Our ref: PS120623-ACO-LTR-LST Rev0 Addendum NIA - Issue b

**25-27 Warriewood Road, Warriewood
Noise Impact Assessment Addendum Letter**

Figure 4.1 Indicative location and extent of solid barrier for the north apartment building rooftop plant platform

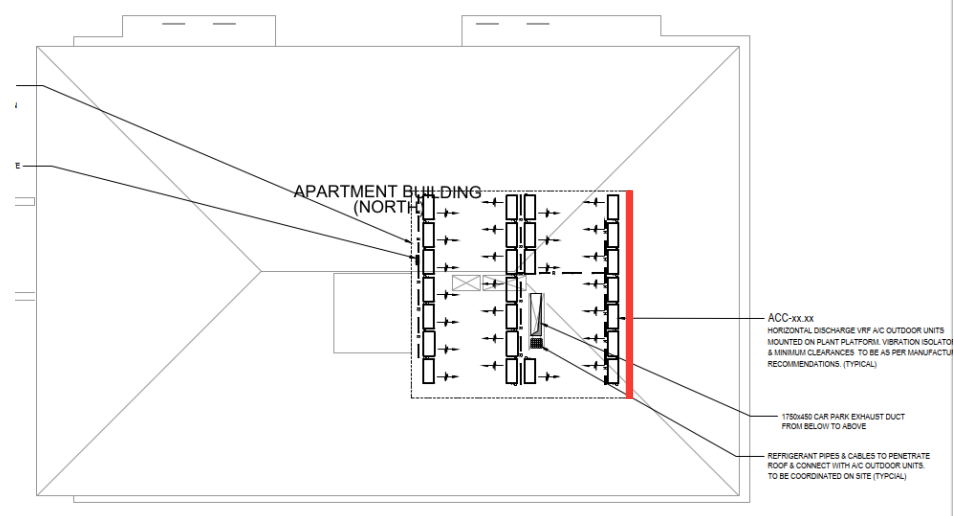
NEAREST RECEIVER	SOURCE AREA	APPROX. DISTANCE, m	INP CRITERIA, dBA Leq, 15 minutes	PREDICTED NOISE LEVELS, dBA Leq, 15 minutes	MITIGATION MEASURES	COMPLIES?
Residential development north of the subject site	Apartment North Plant Platform	35	39 (Night-time)	42	No treatment	No
				34	Noise barrier with height which extends min. 100mm beyond the top	Yes

of VRF units along the northern edge of the platform (see Figure 4.1)	
Residential dwellings along Warriewood Road east of the subject site, 50 to 56 Warriewood Road	Apartment North and South Plant Platforms	75	39 (Night-time)	38	Not required	Yes
Only About Children Childcare facility at 26 Hill Street	Apartment North and South Plant Platforms	75	35 (Internal) (When in use) 45 (External)	38 external (internal level is expected to be < 28 dBA)	Not required	Yes

Figure 4.1 presents the indicative locations and extent of the recommended noise barrier (shown in red) required for north apartment plant platform noise mitigation measure. The length of the barrier is to be for the entire width of the northern edge of the north apartment rooftop platform. The height of the noise barrier shall be a minimum 100mm beyond the top of the installed VRF units.

The noise barrier shall be constructed as a solid element without any gaps or perforations, and shall have a minimum surface mass of 10 kg/m².

Note that the above is a predicted worst case scenario of all indicative VRF units in operation simultaneously. Should quieter VRF units than the assessed be selected (> 5 dB lower), then the noise

barrier treatment recommended above may not be required. This alternative is to be assessed and confirmed by a suitably qualified acoustic professional.
